V2500-A5/D5 SERIES PROPULSION SYSTEM SERVICE BULLETIN

This document transmits Revision 1 to Service Bulletin EV2500-72-0489 and Revision 1 to the Supplement

V2500-ENG-72-0489

ENGINE – ALLOW FOR THE USE OF REOPERATED 2ND STAGE HPT VANES IN NEWER DELIVERED
CONFIGURATIONS

2ND STAGE HPT VANE REOPERATION
FIGURE 1 (SHEET 2 of 3)

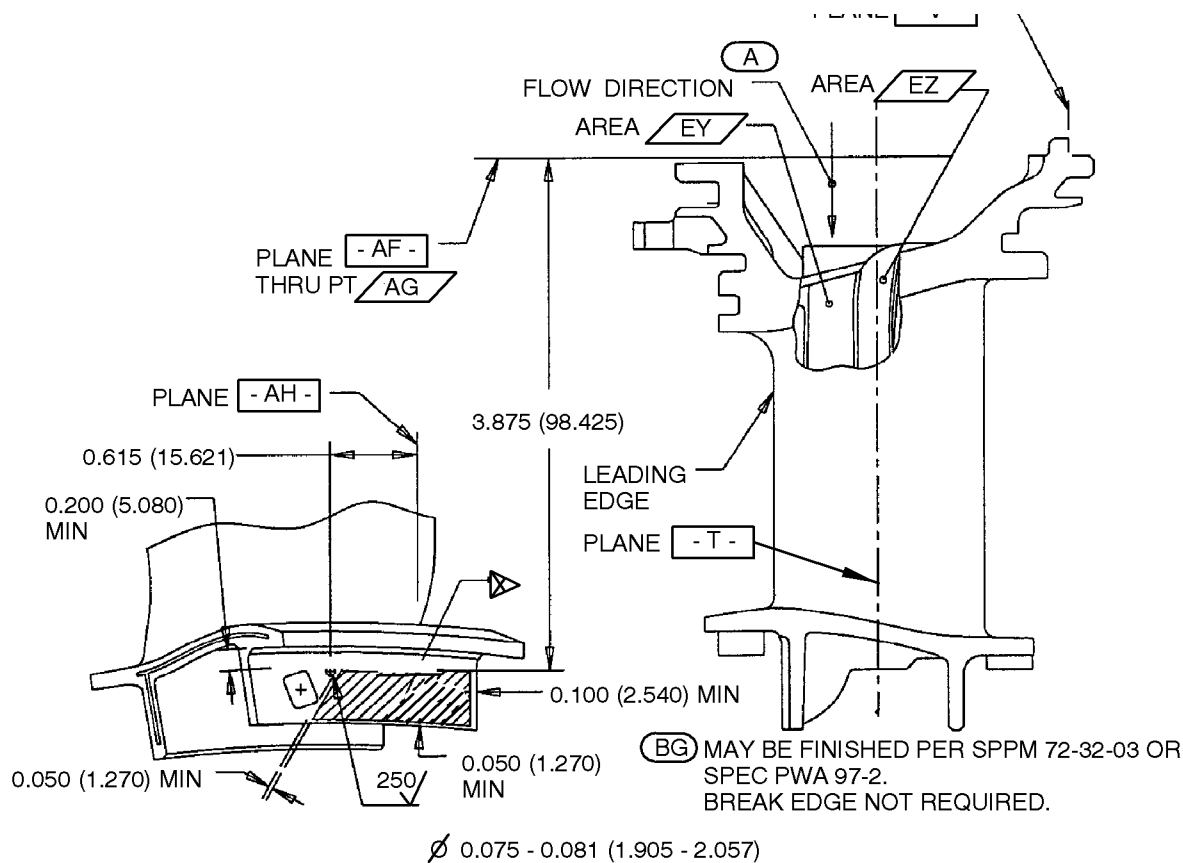
- (a) Set-up and machine one Hole to 0.075-0.081 in. (1.905-2.057 mm) diameter.

The Electrodischarge method given in Task 70-32-03-320-501 may be used. See Reference (3), and Engine Manual Chapter/Section 70-32-03, Finish by Electrochemical or Electrodischarge Metal Removal. See Figure 1 Sheets 1 and 2.

- (b) Flow test passage EY in direction shown with area EZ and leading edge shower head (4 rows total) holes blocked by the procedure specified.

Refer to Reference (9) or (10). See Figure 1 Sheets 1 and 2.

(A) FLOW TEST PASSAGE /EY/ IN DIRECTION SHOWN WITH AREA /EZ/ AND LEADING EDGE & SHOWER HEAD (4 ROWS TOTAL) HOLES BLOCKED PER IAE 70-72-01 OR SPEC PWA 322 TO OBTAIN AIRFLOW LEVEL OF:

$\left(\frac{P_3}{P_a}\right)_{\text{MIN}}$	$\left(\frac{P_3}{P_a}\right)_{\text{TARGET REF}}$	$\left(\frac{P_3}{P_a}\right)_{\text{MAX}}$
$\frac{W\sqrt{T_3}}{P_a} = 0.184$ (4.674)	BSC LIMIT	1.412 (35.865)	1.500 (38.100)	1.621 (41.173)

2ND STAGE HPT VANE REOPERATION
FIGURE 1 (SHEET 3 of 3)

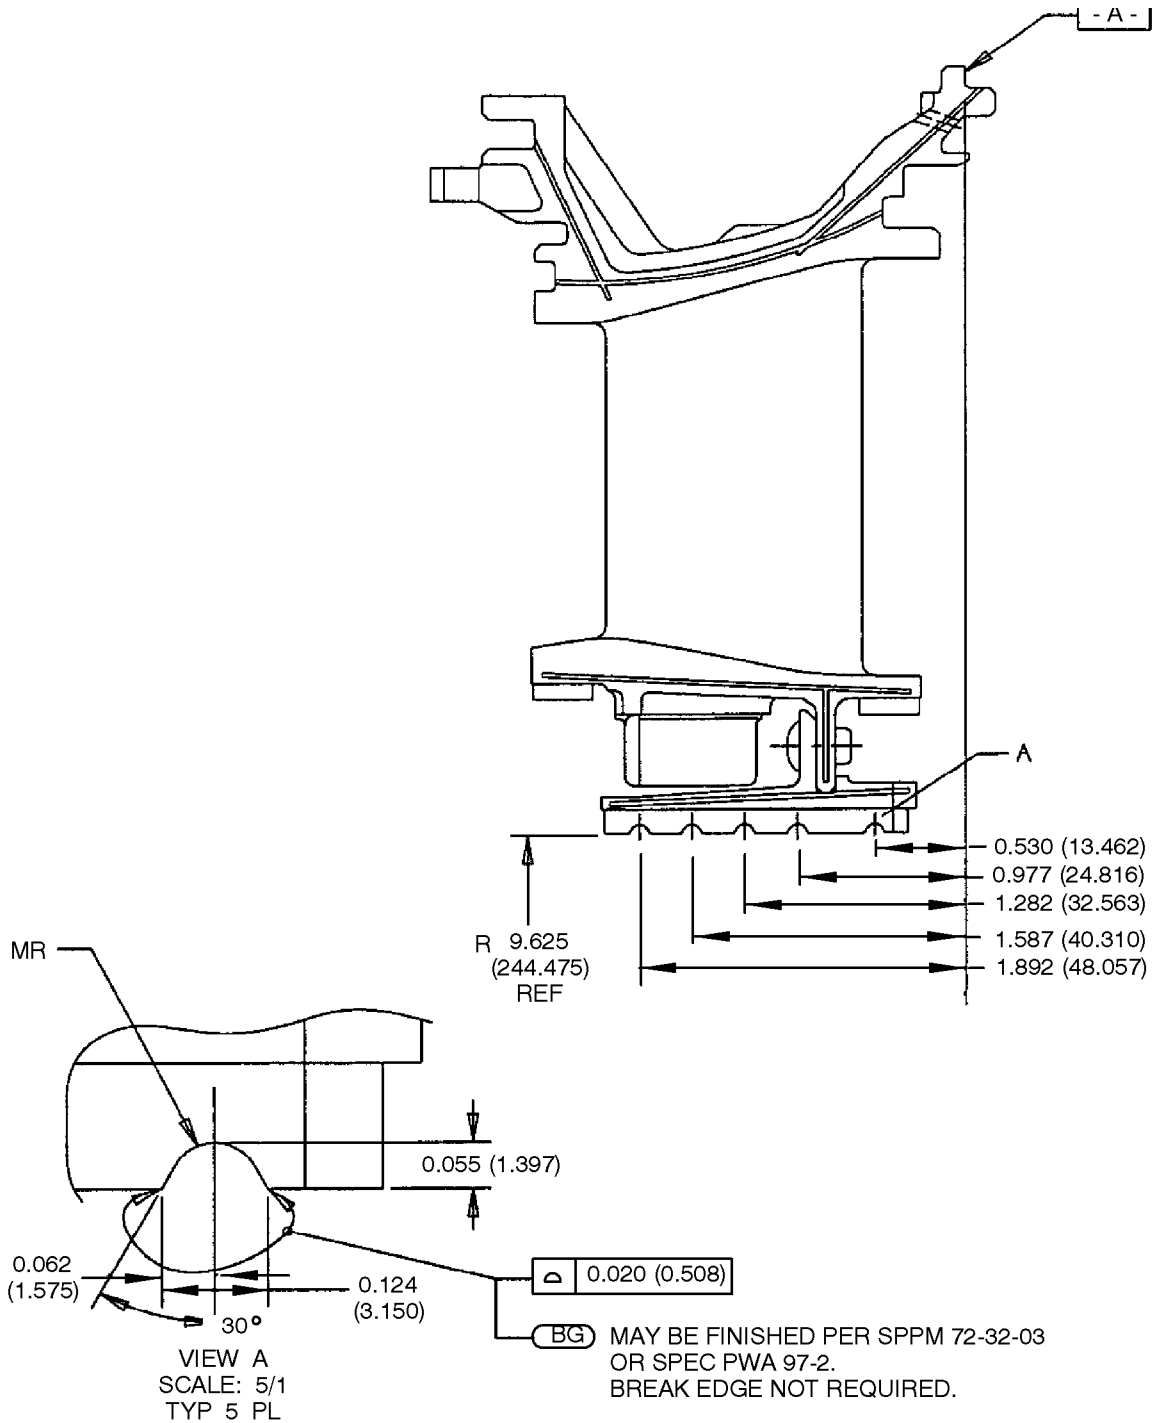
(i) When using Seal PN 2A1106-01 machine per Figure 1 Sheet 3

SURFACE TEXTURE PER SPEC IAE 70-35-09 OR PWA 388. UOS ALL SURFACES 125/
UOS BREAK EDGES 0.030 (0.762) MAXIMUM.

FAMILY TREE - 2ND STAGE HPT VANE ASSEMBLY REF. CATALOG SEQUENCE NO. 72-45-24 FIGURE 02 ITEMS 130, 360 AND 420.
CHART A

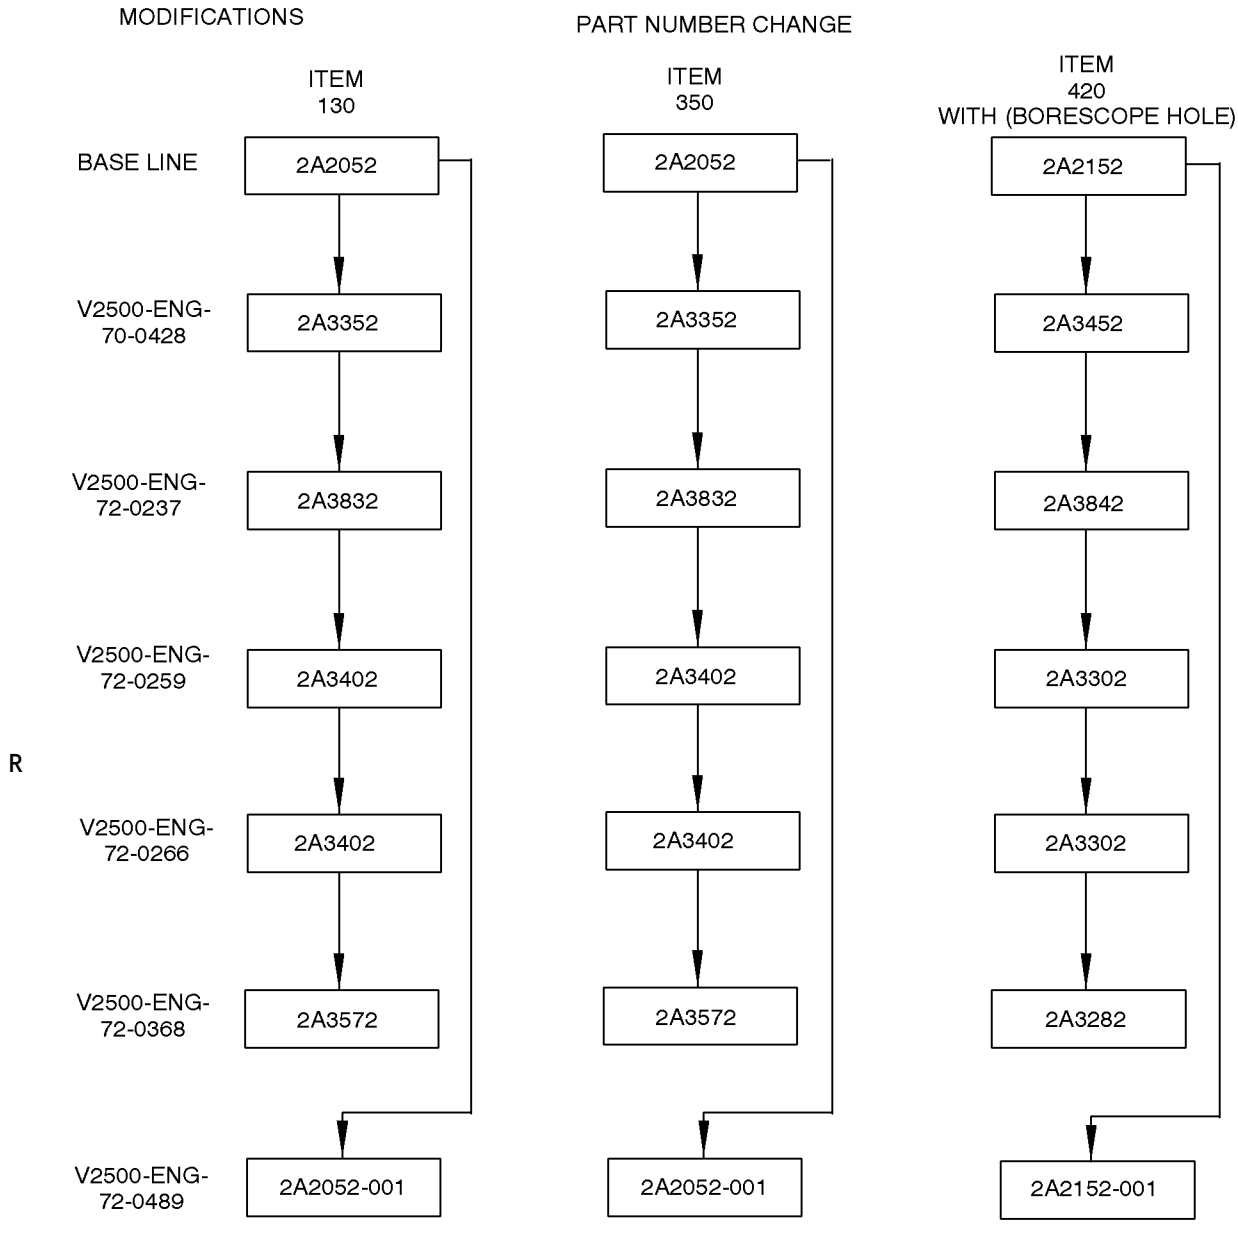
- (1) Do a modification of the Stage 2 HPT Vane Assembly PN 2A2052 and 2A2152 (See Reference (8), 72-45-24 Figure/Item No. 02-130, 02-350 and 02-420 respectively).

- R (c) After modification identify old Vane Assembly PN 2A2052 as 2A2052-001
R and old PN 2A2152 as 2A2152-001.

R FAMILY TREE - RING SEGMENT AND VANE CLUSTER ASSEMBLY OF REF. CATALOG SEQUENCE NO.
 R 72-45-24 FIGURE 02 ITEM 050.
 CHART B

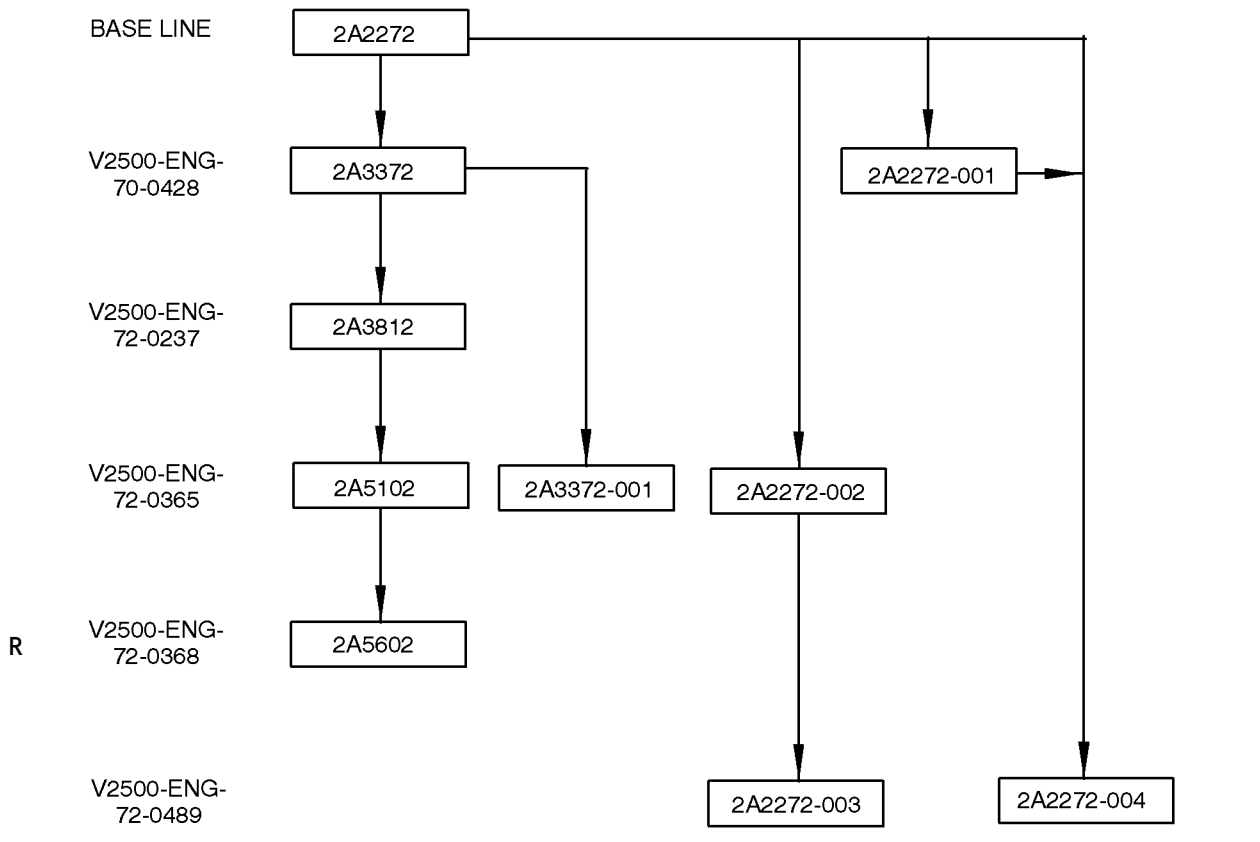
- R (2) Assemble the Ring Segment and Vane Cluster Assembly PN 2A2272, 2A2272-001,
R 2A2272-002 or 2A2372, 2A2372-001, 2A2372-002 using the modified parts by
the procedure specified in Reference (9) or (10), Chapter/Section
72-45-24, repair-18 (VRS 3391).

- R (a) Identify the new Ring Segment and Vane Cluster Assemblies in
R accordance with the Reidentified Parts section of this Service
R Bulletin.
